East Anglia ONE North and East Anglia TWO Offshore Windfarms

Notice of Intent to Make Non-material or Material Changes

Applicant: East Anglia TWO Limited and East Anglia ONE North Limited

Document Reference: ExA.AS-1.D1.V1

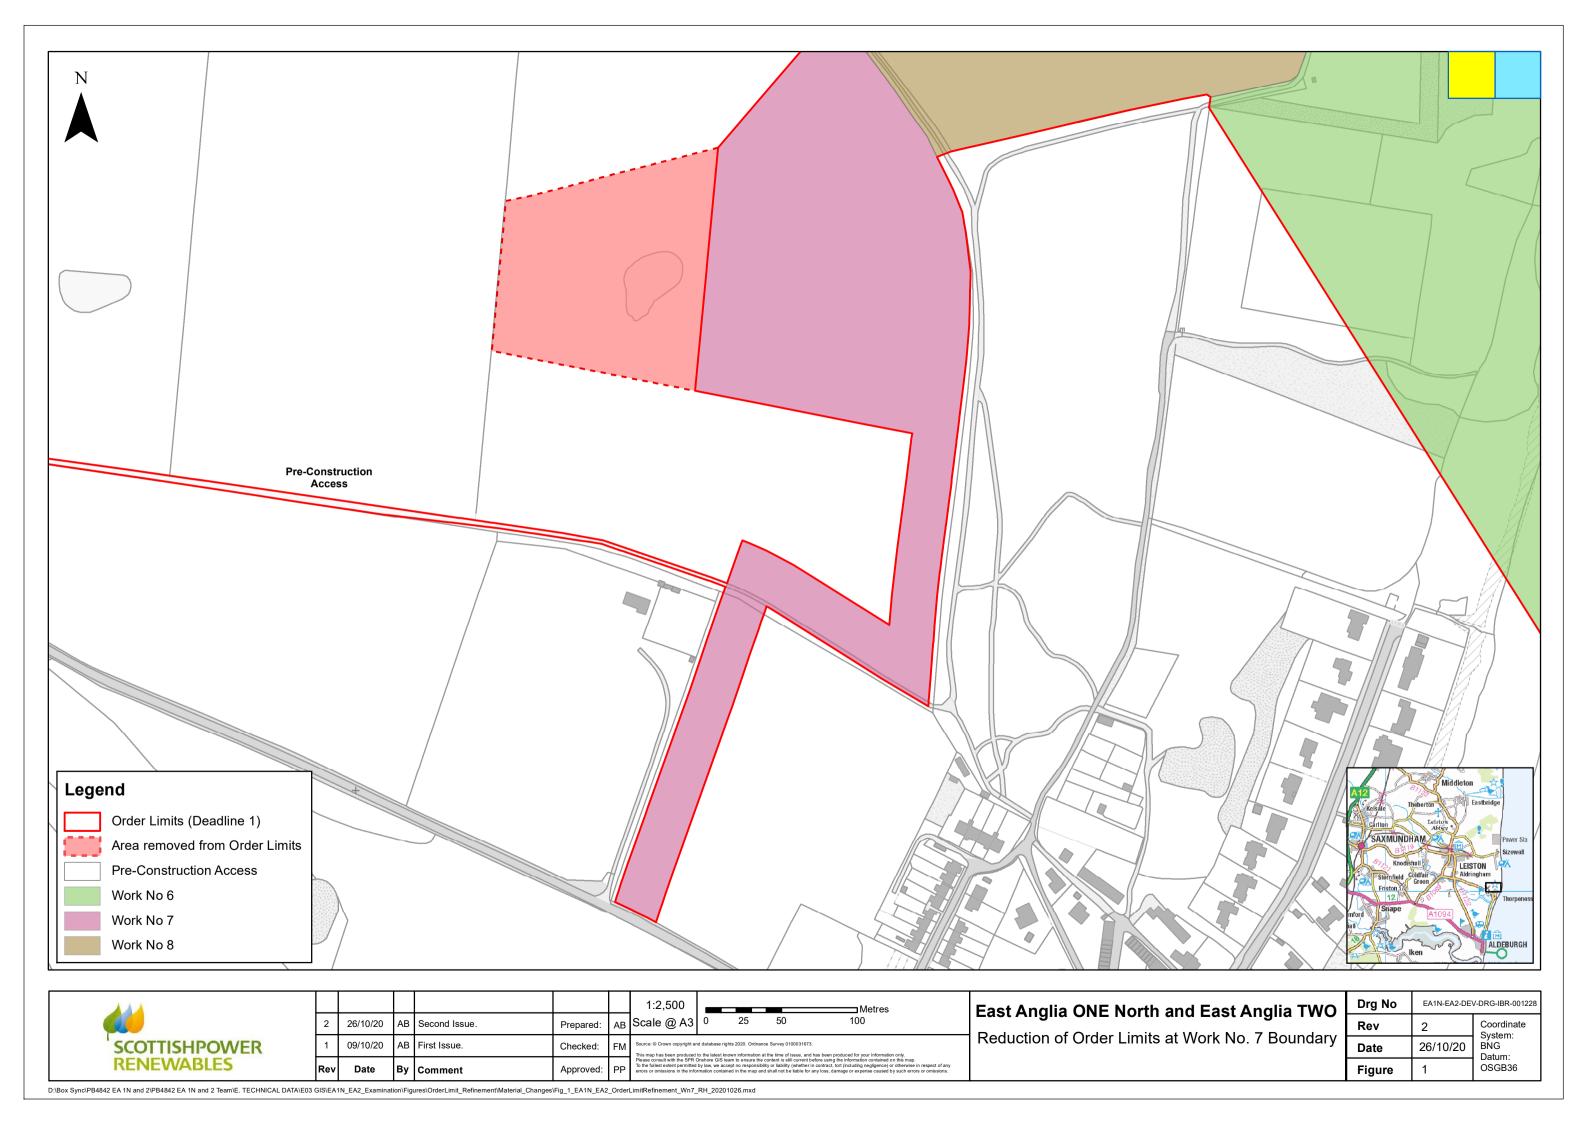
2.4 Reduction of Order Limits at Work No. 7

- 13. The Applicants have amended the Projects' Order limits to reduce their extent at the western boundary of Work No. 7.
- 14. This reduction will remove approximately 1.78 hectares from the Projects' Order limits and has been facilitated by the Applicants' review and refinement of the land required within Work No. 7 to construct the Projects. The reduction allows the ongoing agricultural use of this area to continue without interruption.

15. Figure 1 (Appendix 1) shows the extent of this non-material change.

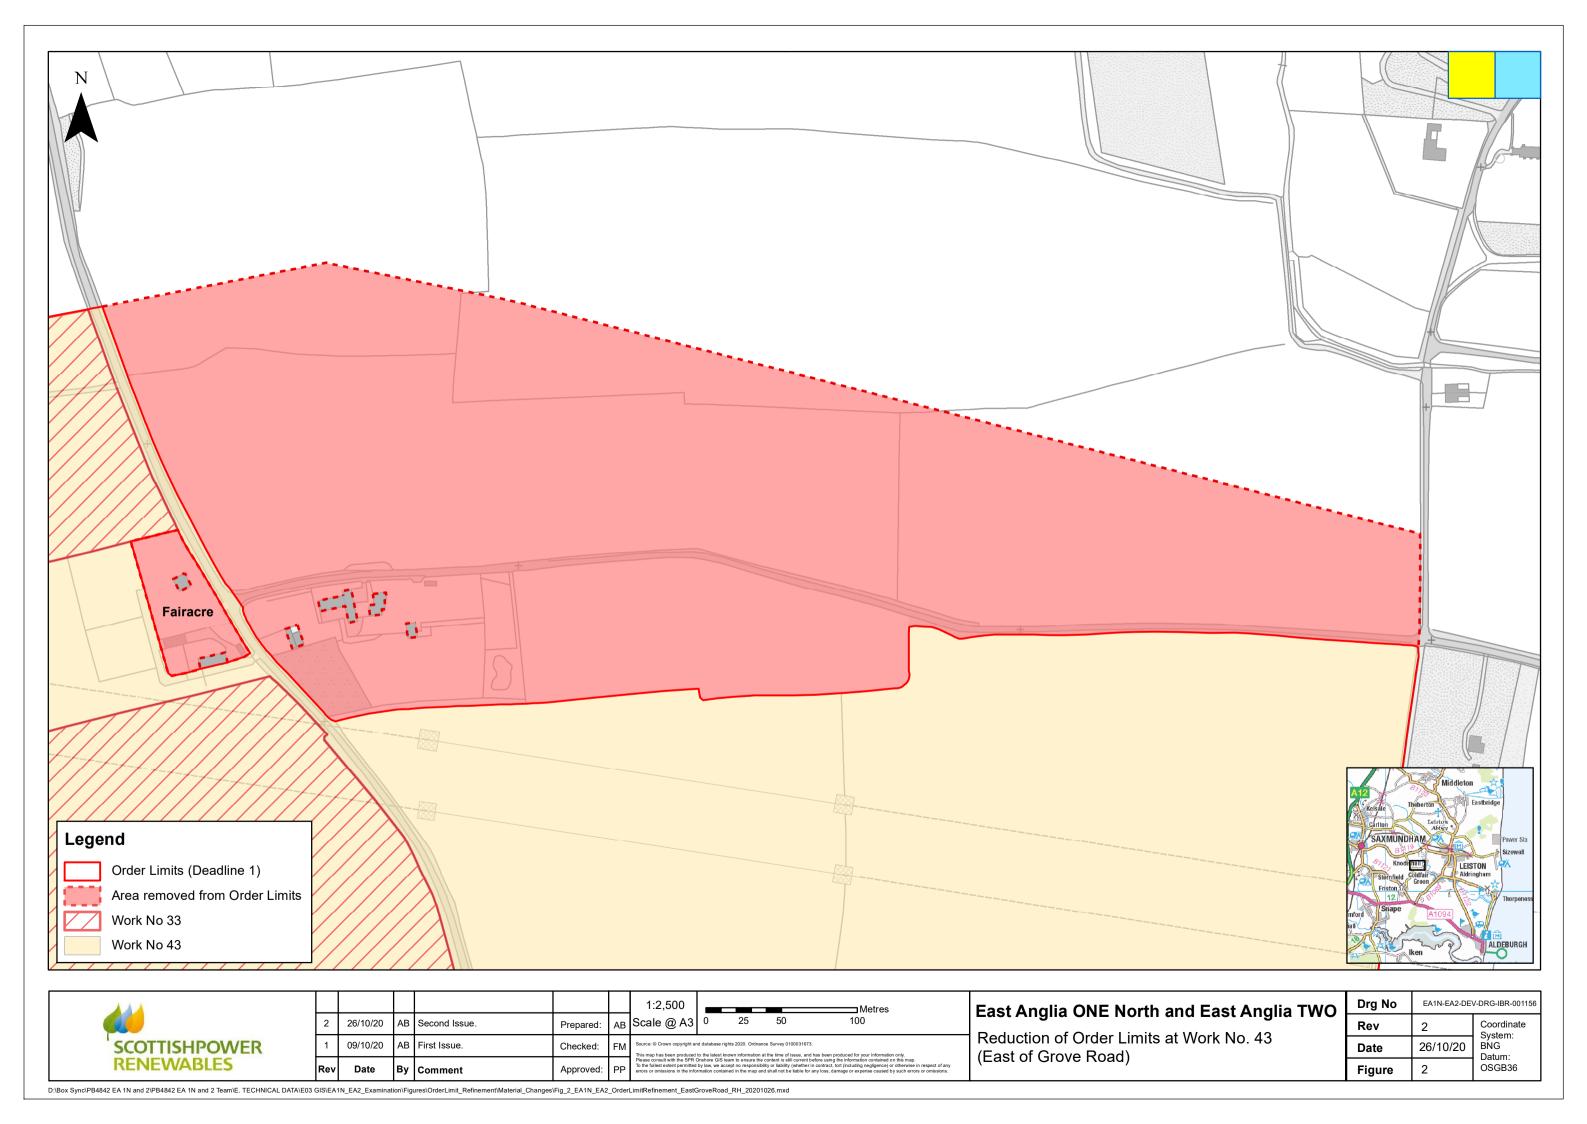
2.5 Reduction of Order Limits at Work No. 43 (East of Grove Road)

- 16. The Applicants have amended the Projects' Order limits at Work No. 43 (east of Grove Road) to reduce their extent.
- 17. Ongoing preliminary design works undertaken by National Grid Electricity Transmission plc (NGET) regarding the overhead line realignment works has facilitated the removal of approximately 15.69 hectares from the Projects' Order limits in this area, removing agricultural land and residential garden areas from the Order limits.
- 18. *Figure 2 (Appendix 1)* shows the extent of this non-material change.

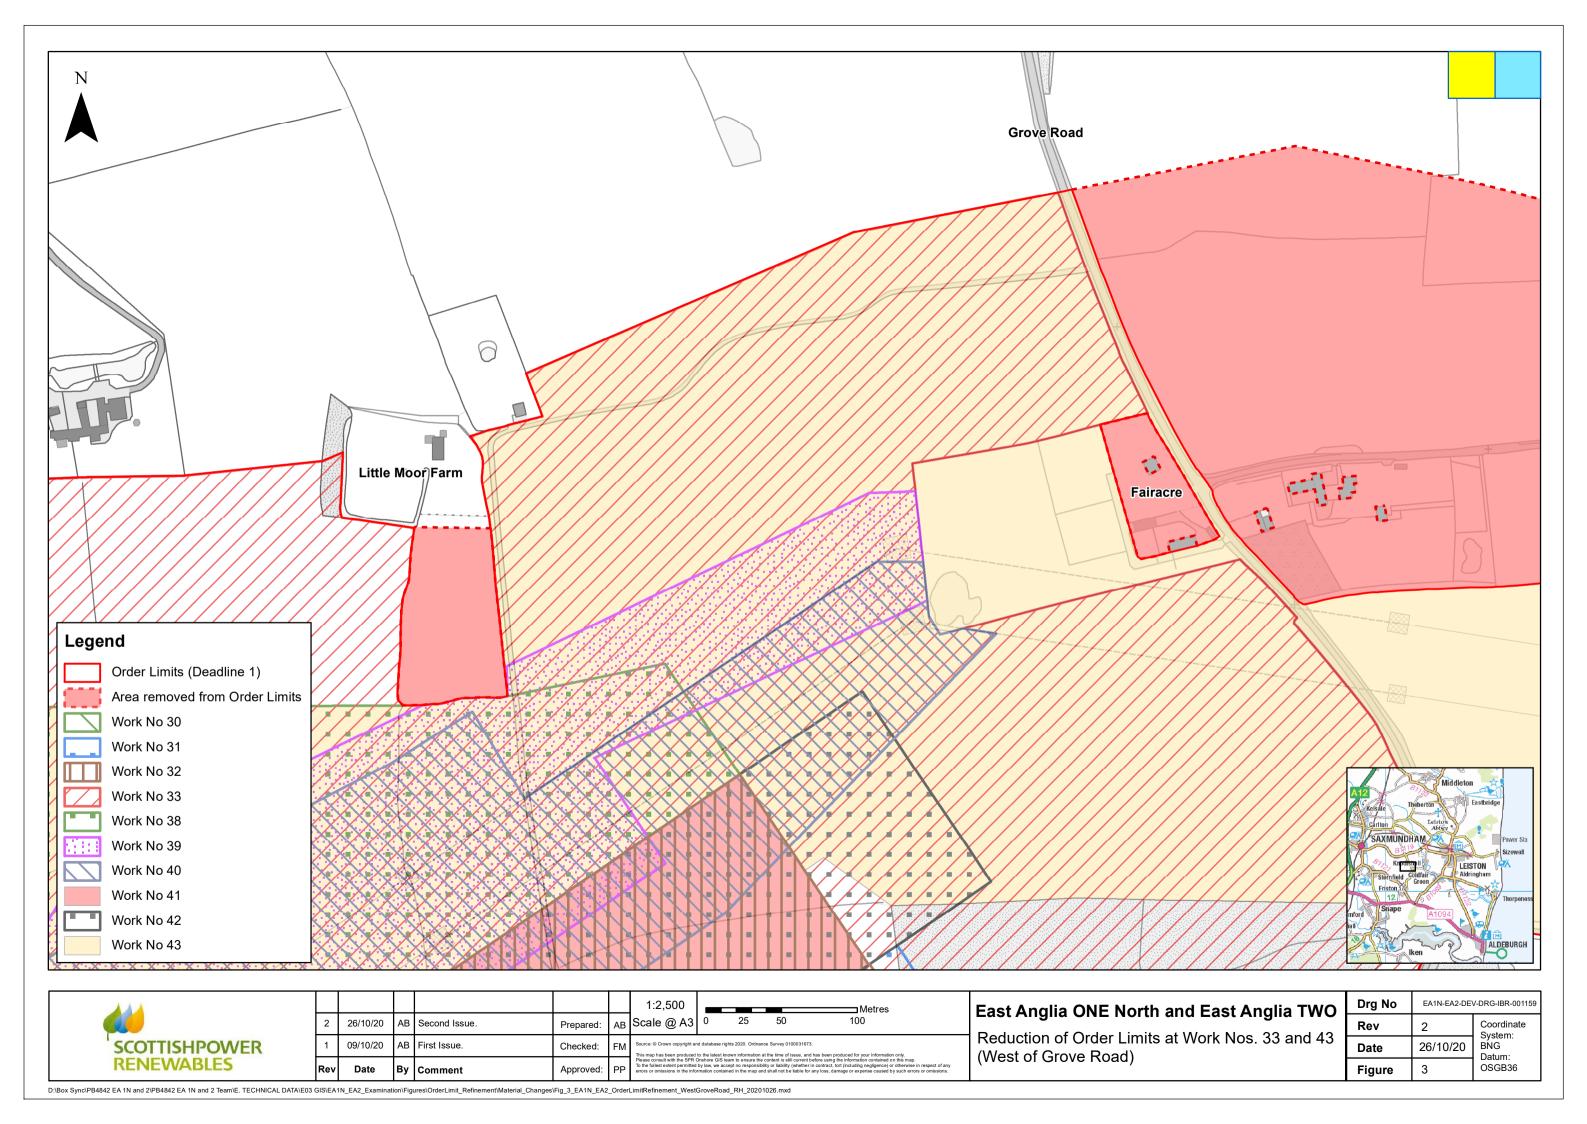
2.6 Reduction of Order Limits at Work Nos. 33 and 43 (West of Grove Road)

- 19. The Applicants have amended the Projects' Order limits at Work Nos. 33 and 43 west of Grove Road to remove the residential garden at Fairacre (at Work No. 43) and the residential garden at Little Moor Farm (at Work Nos. 33 and 43).
- 20. Ongoing preliminary design of the overhead line realignment works undertaken by NGET has facilitated the reduction of the Order limits in these areas.
- 21. *Figure 3 (Appendix 1)* shows the extent of this non-material change.

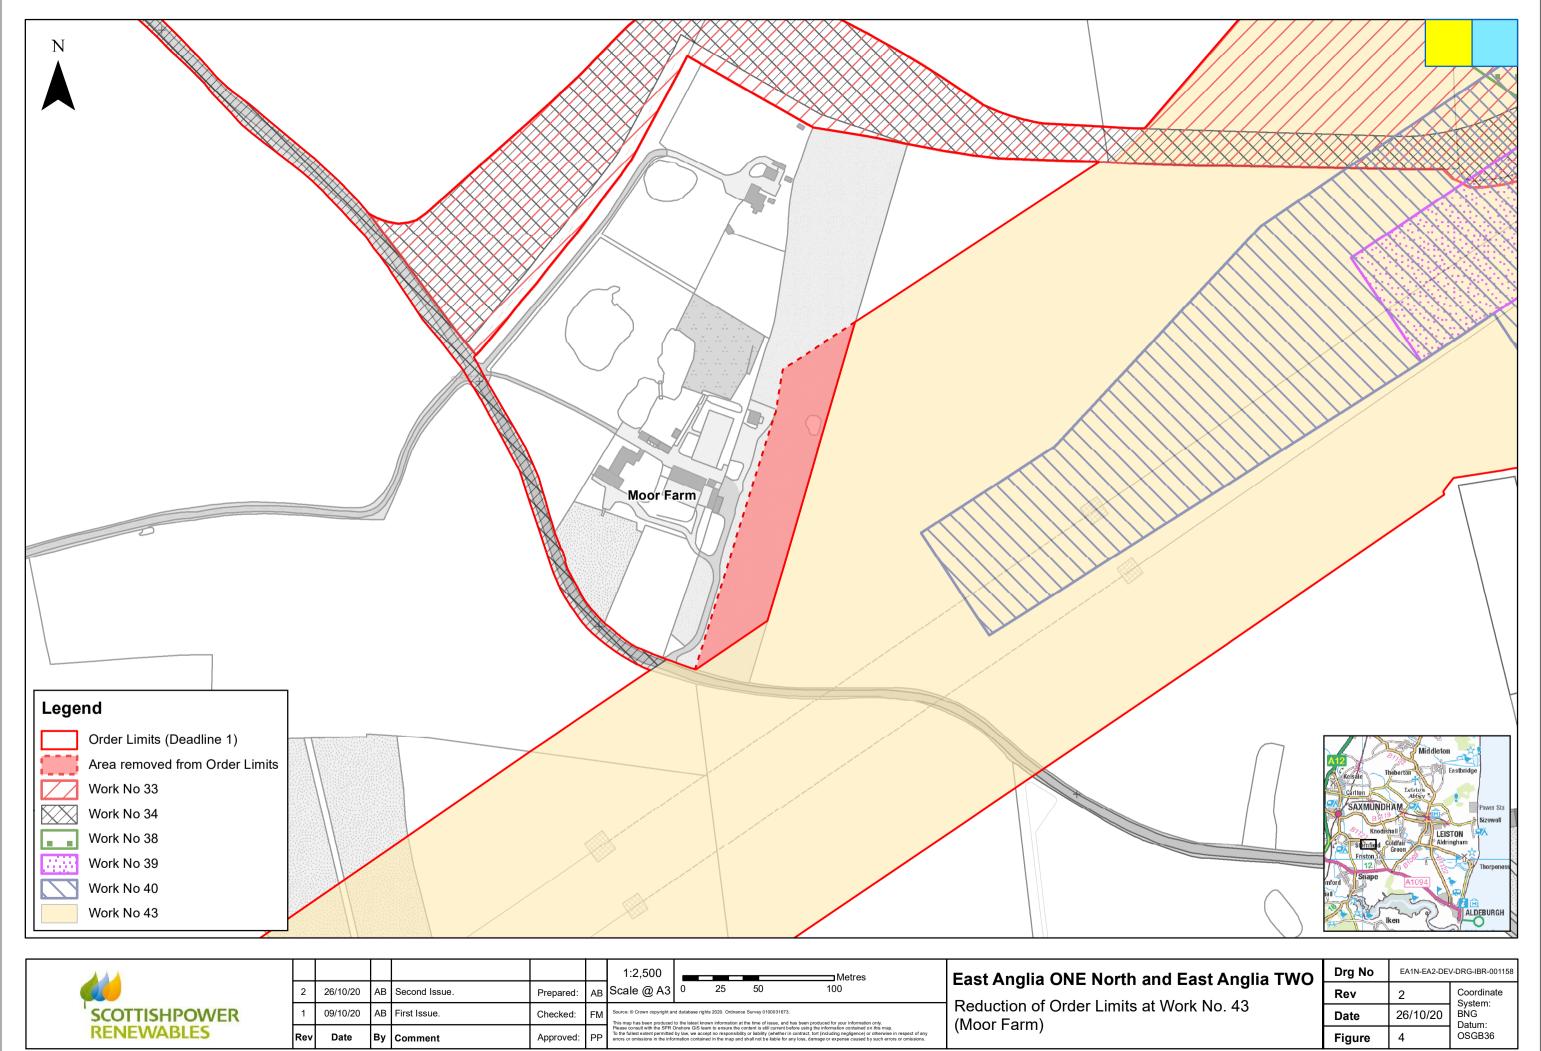
2.7 Reduction of Order Limits at Work No. 43 (Moor Farm)

- 22. The Applicants have amended the Projects' Order limits to reduce their extent at Work No. 43 (Moor Farm).
- 23. Ongoing preliminary design works undertaken by NGET regarding the overhead line realignment works has facilitated the removal of an area of amenity woodland and curtilage at Moor Farm from the Order limits.
- 24. *Figure 4 (Appendix 1)* shows the extent of this non-material change.

-				
Box Sync\PB4842 EA 1N and 2\PB4842 EA 1N and 2 Team\E. TECHNICAL DATA\E03	GIS\EA	N_EA2_Examinati	on\Figu	res\OrderLimit_Refinement\Material_Changes	Fig 5 EA1N EA2	Order	LimitRefinement_FridayStreet_RH_20201026.mxd

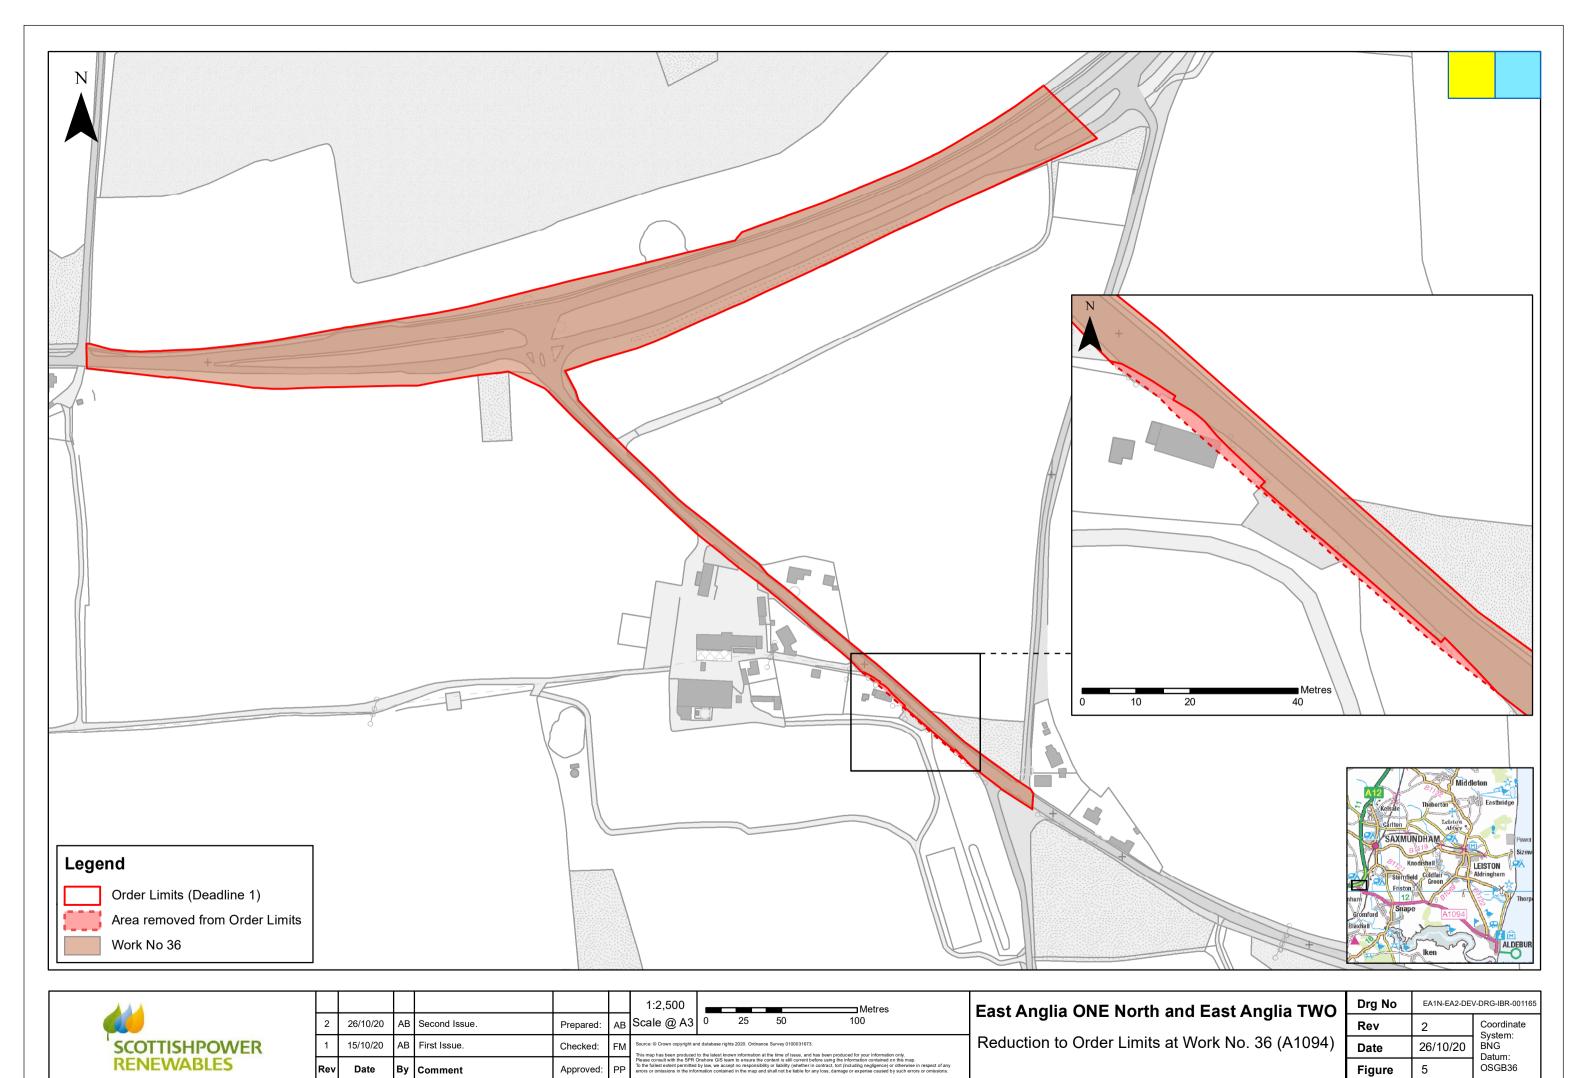
2.8 Reduction of Order Limits at Work No. 36 (A1094)

- 25. The Applicants have amended the Projects' Order limits to reduce their extent at the A1094, to the east of its junction with the A12.
- 26. The Applicants have identified that the Order limits along the A1094 encroach unnecessarily into a residential title, and have therefore reduced the Order limits so that they extend to the highway boundary instead.

27. *Figure 5 (Appendix 1)* shows the extent of this non-material change.
